VILLAGE OF LOMBARD
REQUEST FOR BOARD OF TRUSTEES ACTION
 For Inclusion on Board Agenda

TITLE: 2013 Sanitary Sewer Lining Program
 Change Order No. # 2

To: Tim Sexton, Acting Village Manager
Through: Carl Goldsmith, Director of Public Works *CJ*
From: David A. Dratnol, P.E., Village Engineer *DAD by DES*
Date: August 20, 2013
Subject: FY 2013 Sanitary Sewer Lining Program – Change Order # 2

VILLAGE OF LOMBARD CHANGE ORDER

CHARING CROSS
REAR YARD EASEMENT

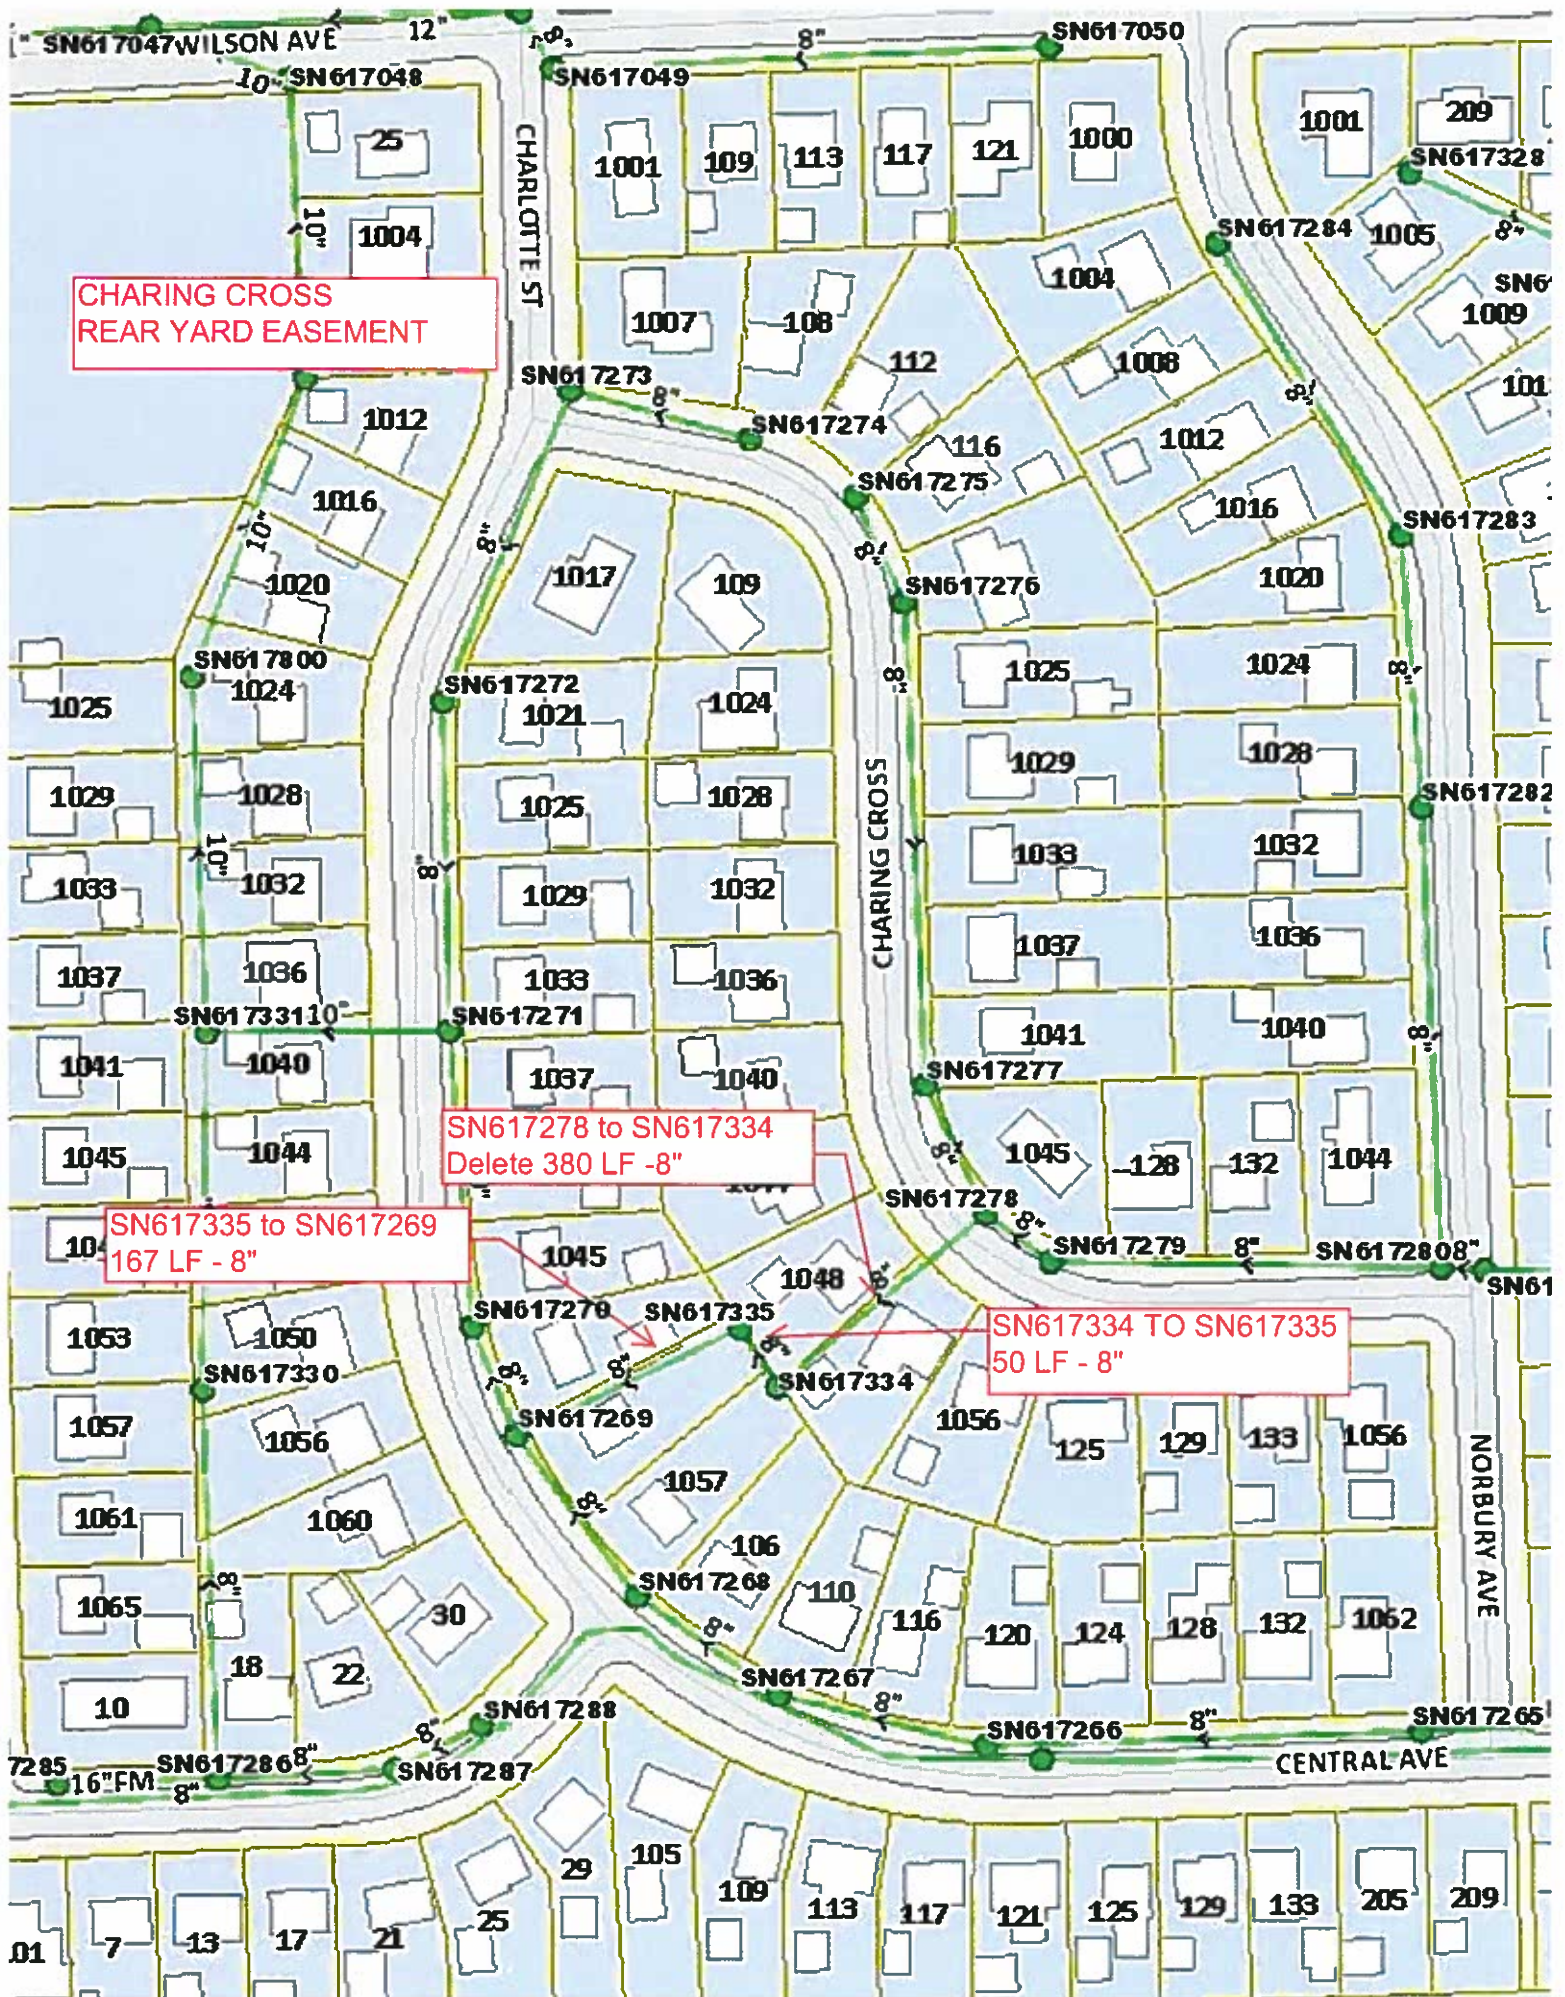
SN617278 to SN617334
Delete 380 LF -8"

SN617335 to SN617269
167 LF -8"

SN617334 TO SN617335
50 LF -8"

FINLEY RD
12" STORM

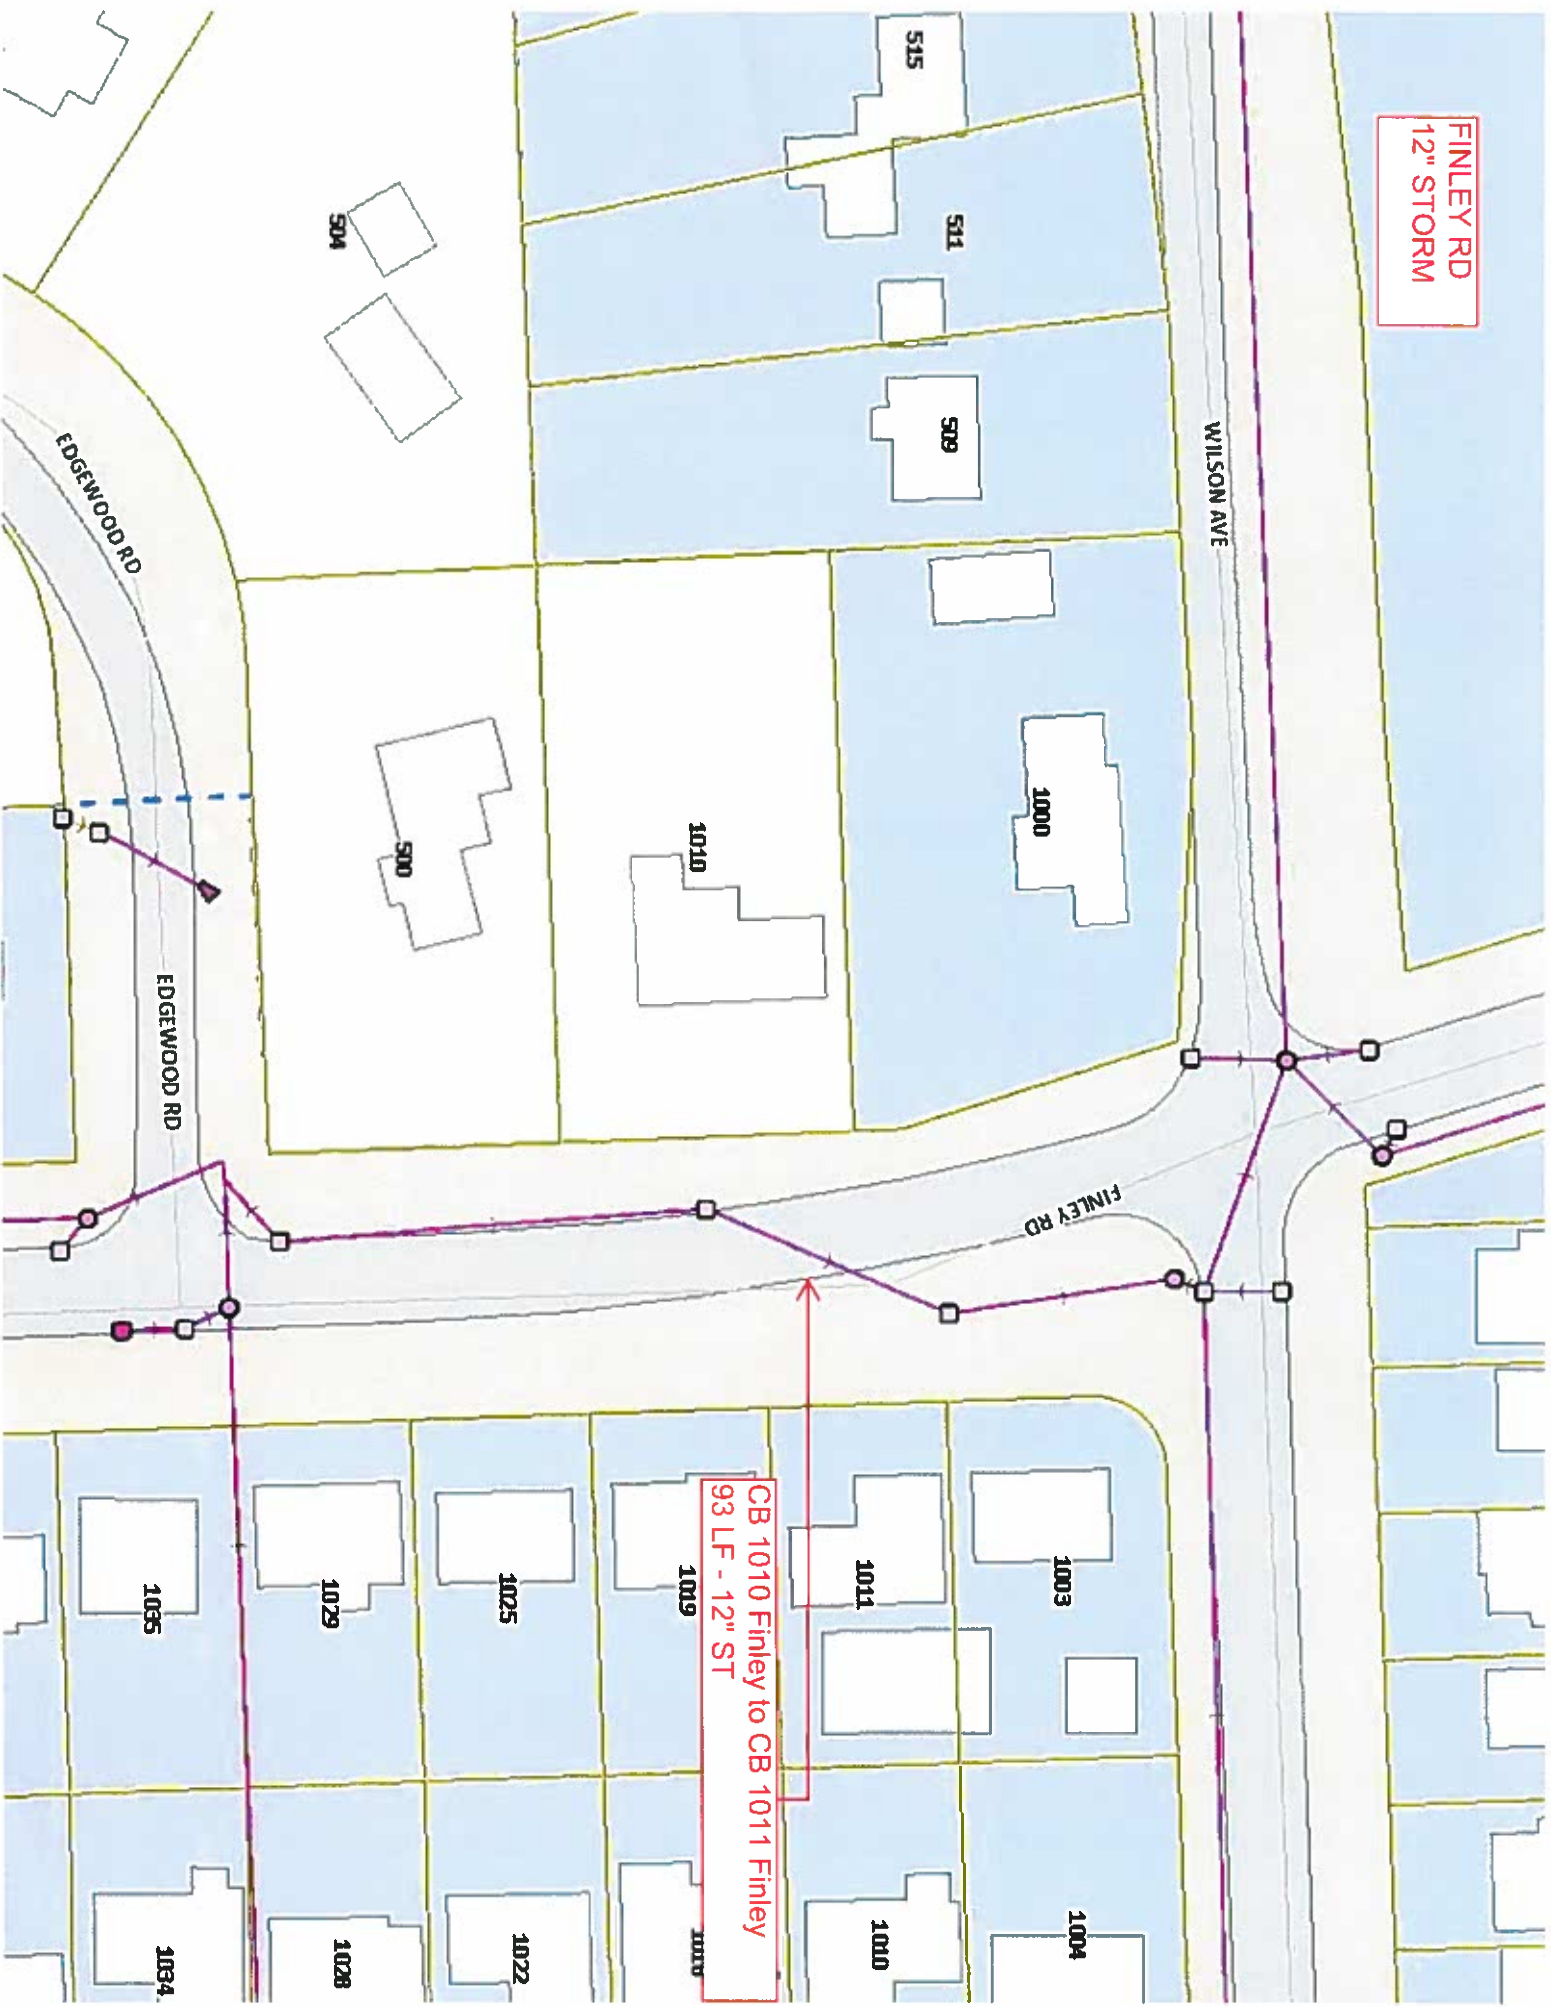
CB 1010 Finley to CB 1011 Finley
93 LF - 12" ST

12" Storm Sewer on Grove, east of Elizabeth
